NORTHERN
BEACHES
COUNCIL

RE Mod2019/0172 - DA2015/1258 dated 23/4/19 on Council's DA website
And amended submission dated 31/7/19

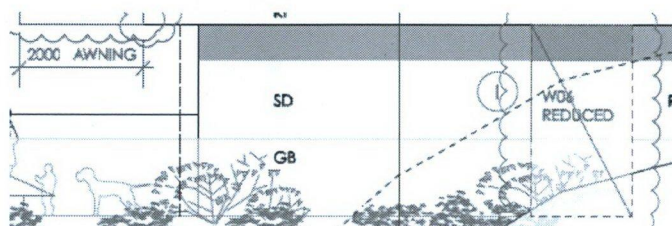
We believe the sequence of plans submitted by the owner over the course of this development show that as a result of our objections to the amount of excavation of this site, the owners have developed a way of explaining the reason for the excessive excavation of this site. This can be seen in what will now be an entrance way through the concrete wall of the original plan to provide access to this proposed water storage tank area (green amended plan diagram). As this amendment is actually a **request** to undertake modifications to plans already lodged, the question of whether this doorway has already been cut

POOR GROUND CONDITIONS REQUIRED THIS ZONE TO CUT BACK TO SOLID ROCK
HENCE THE CLIENT UTILIZATION OF THIS AREA FOR STORMWATER TANK STORAGE

POOR GROUND CONDITIONS REQUIRED THESE ZONES TO CUT BACK TO SOLID ROCK
HENCE THE CLIENT UTILIZATION FOR THE PROPOSED STORAGE AREA

through the original concrete wall which showed no access doorway (red rectangle on original plan) must surely be asked.

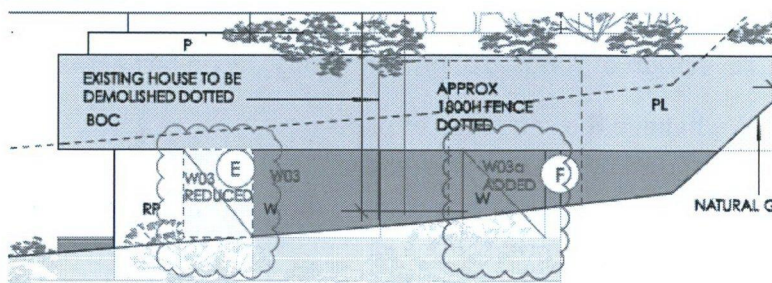
1. Windows modified with both an increase & decrease in size and 2 new windows. We objected to both the size and position of the windows on the eastern boundary, especially those in the south-eastern corner which are not windows but actually sliding doors (SD) with a glass balustrade (GB). They provide the occupants with the ability to look straight into our kitchen, back deck and bathroom and not even the approximately 1800 mm high fence (shown by the dotted line) will obstruct their view into our home.

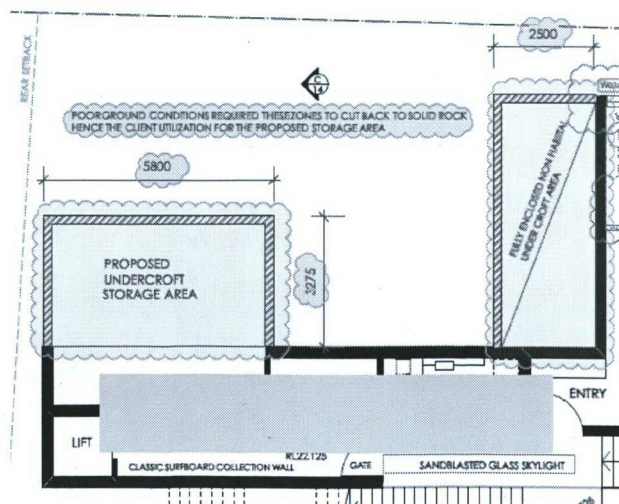
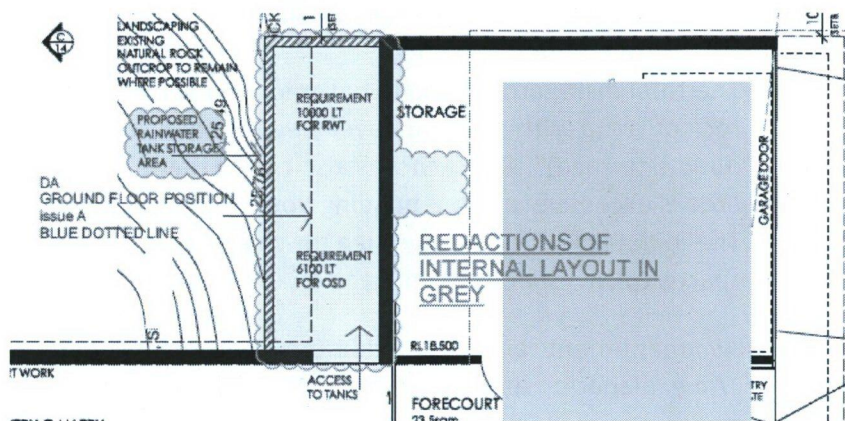
The last of these four items is the only one with which we are pleased, namely the construction of a **retaining wall and boulder stability work** being suggested in the north-eastern corner of the property. The engineer who has been advising the owner, Mr Troy Crozier has noted in his email to us,

Given the number of indiscretions which have occurred during the excavation and building of this development, we are completely unsure of whether these “sensible excavation techniques” have been employed by the owner. Although this rock seems to not have moved, there was always the possibility that it might move at some stage in the future. While it was something we knew might happen, it was not something we believed that we had to spend money on now. We would deal with it when and if it happened in the future. But once the rock was sawn through, despite being advised by the original builder that it, “most probably will not be touched”, we did believe there was an increased risk of the rock moving.

So this aspect of the amended modification is what we hope will be a good thing. We do hope that it is carried out carefully. Also, as the retaining wall is to be constructed to include “boulder stability” we would hope that we are fully informed about the work that is to be done to stabilise this very large boulder which now sits on our property. We would also hope that a geotechnical engineer such as Mr Crozier is involved in providing advice about the design and planning of this piece of work.

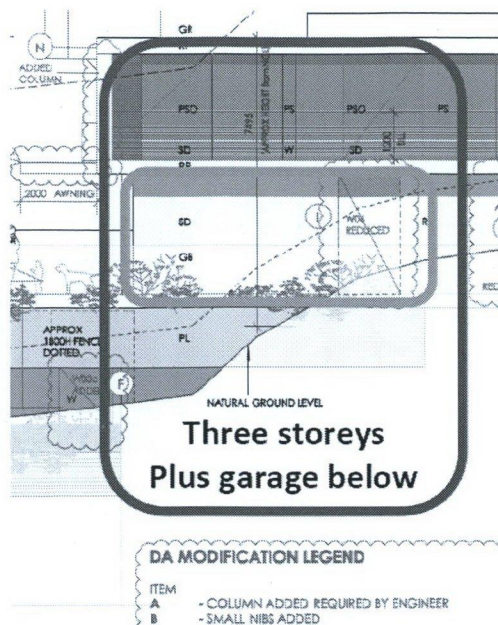
Page 1 of the amended plans shows the ground floor level of the building, with the garage entrance, as well as giving information about the positioning of the proposed rainwater storage tank, with its new access doorway. Immediately to the north of this tank, there is a section of the rock escarpment which was retained, although it is now covered up by the main section of the upstairs building. Further to the north of the block, we believe there was additional excavation carried out which is not shown on the plans, with a further concrete slab poured in this position, although this is difficult to ascertain due to the blue mesh material placed on the security fencing to hide the construction work being carried out.

The second page of the amended modification shows an additional “Proposed undercroft storage area”. If, as we believe there was a concrete floor poured in this position below, then this proposed undercroft storage area is being constructed so that it sits on top of the concrete floor below with nothing in between. Either that or it is sitting in mid-air with nothing below it!

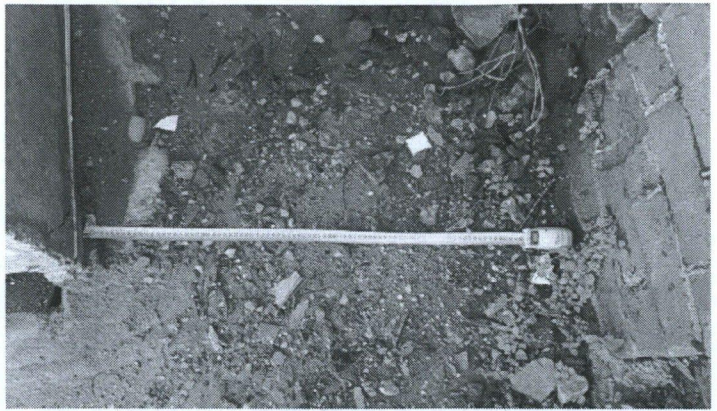
This photo is one I have previously provided Council and shows that there is only 900mm between the eastern wall of the new building and our western wall. This indicates how much the owner has not adhered to the 2.0m guideline, "to enable sufficient space for planting".

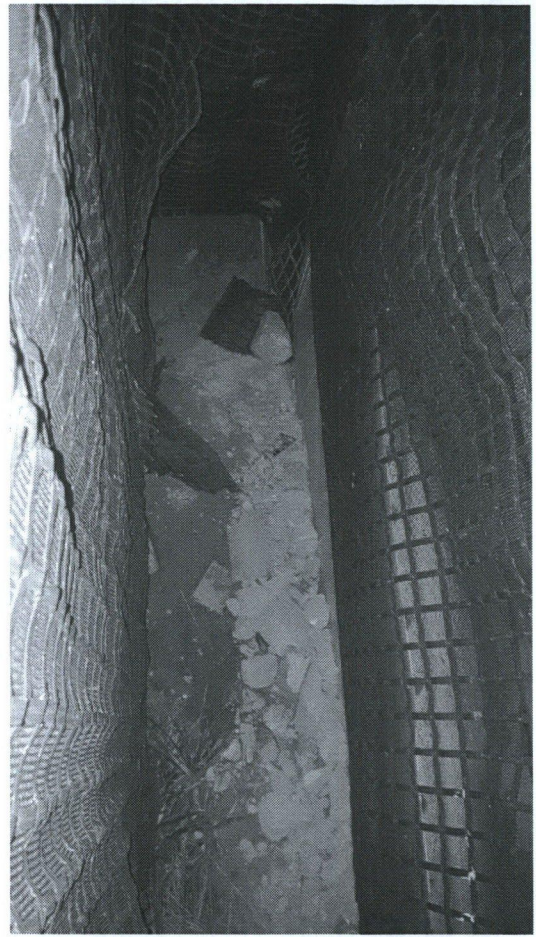
These photos show what we believe was the lack of commitment by the owner to adhere to these DA requirements for "deep-soil planting". Behind the retaining wall (on the LHS of the first photo), built to hold back the soil on the 64 Evans Street side of the boundary, the owner/builder has filled the void with building rubble, such as concrete and building waste. The first photo

was taken in the early stages of the rubbish disposal and the second photo was taken at night (12/8/19) and shows the space completely filled with building rubbish. This area is actually on the 62 Evans Street side of the boundary and following the DA requirements for "deep soil planting", it should have been filled with soil, to allow for that planting. But instead, the owner/builder just wants to install a metal privacy screen, covered in jasmine, and not have to worry about deep-soil planting.
